Technical Bulletin

Load Push/Pull Sideshift Cylinder Bracket Interference

MODELS: 30C and 45C Load Push/Pulls

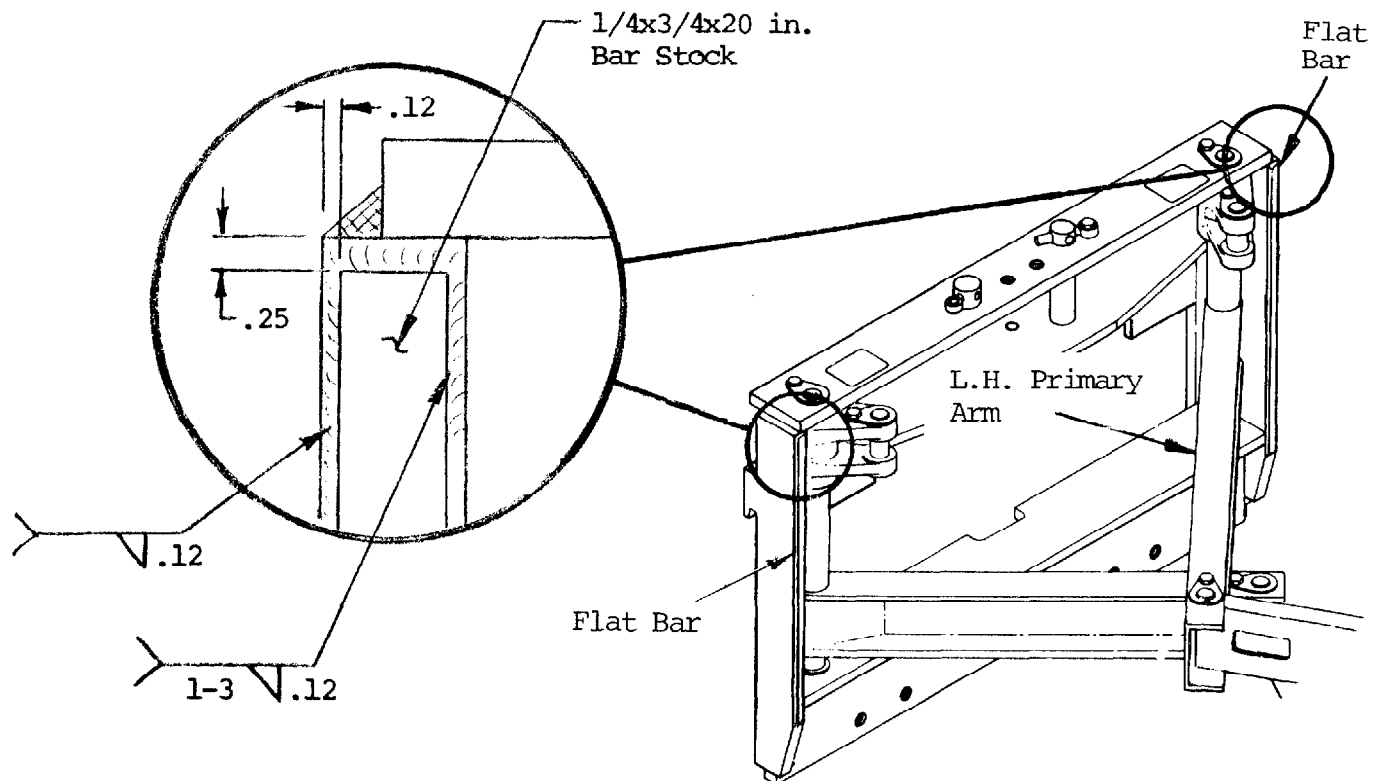
PROBLEM: On sideshifting models, when the faceplate is fully retracted, the L.H. primary arm may interfere with the sideshift cylinder anchor bracket.

SOLUTION: Weld two pieces of 1/4x3/4x20 in. mild steel flat bar to the frame face at the locations shown below. The faceplate on retraction will then bottom on the flat bars and leave sufficient clearance between the sideshift cylinder bracket and the L.H. primary arm.
